ALERT SERVICE BULLETIN

412CF-20-70

MODEL AFFECTED: 412CF

SUBJECT: FUEL CHECK VALVE P/N 209-062-607-001,
INSPECTION AND REPLACEMENT OF.

Figure 3. Fuel Check Valve Outside Diameter Measurement

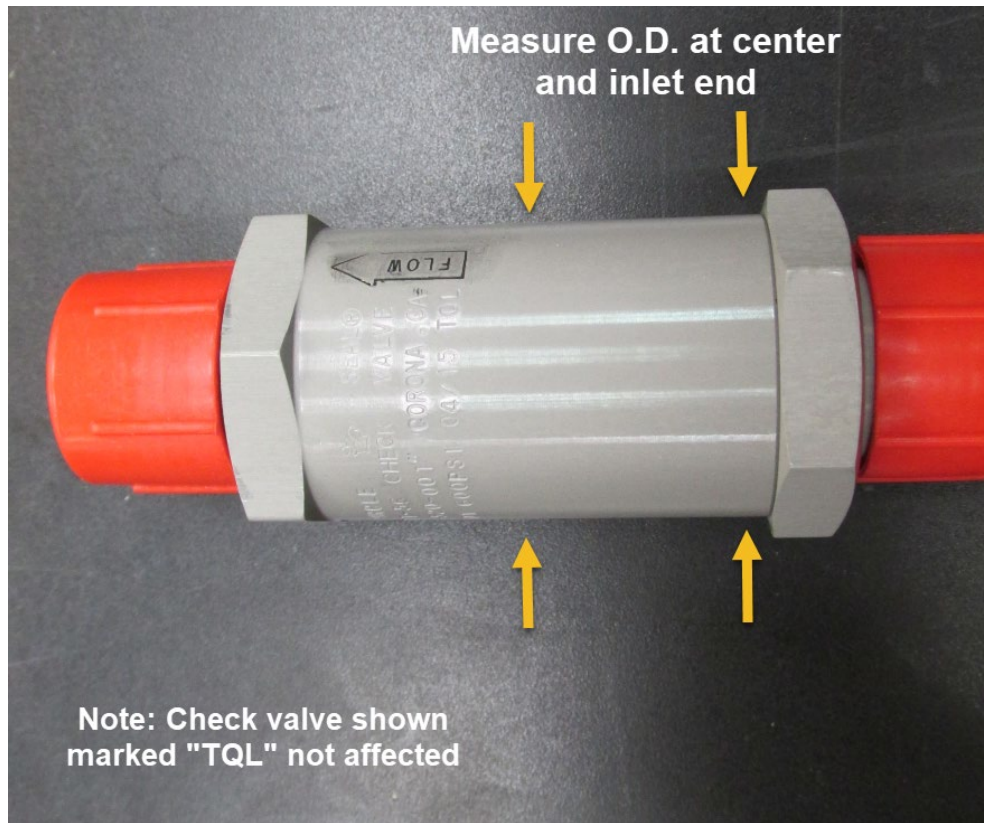
- 1. Prepare the helicopter for maintenance and gain access to the fuel check valves (Figure 1).
- 2. Using a strong light source, visually inspect the fuel check valves for general condition and fuel leaks. Inspect for cracks at the inlet end where the threaded fitting is installed (Figure 3).
- 3. If a crack is found, replace the check valve prior to next flight. Figure 4 shows an example of a cracked check valve.
- 4. If no cracks or any other defects that would cause the valve to be unserviceable are found, make an entry in the helicopter logbook and historical service records indicating the findings and that Part II will require accomplishment until Part III is accomplished.

- d. If the dimension measured at the inlet end is greater than 0.003 inch (0.0762 mm) when compared to the measurement at the center, the valve will require replacement. Part III can be accomplished immediately, or Part II can be accomplished until the defective valve can be replaced in accordance with Part III.
- e. If the defective check valve is not replaced immediately, make an entry in the helicopter logbook and historical service records indicating the findings and that Part II must be accomplished every 25 flight hours or 30 days whichever comes first until Part III is accomplished.
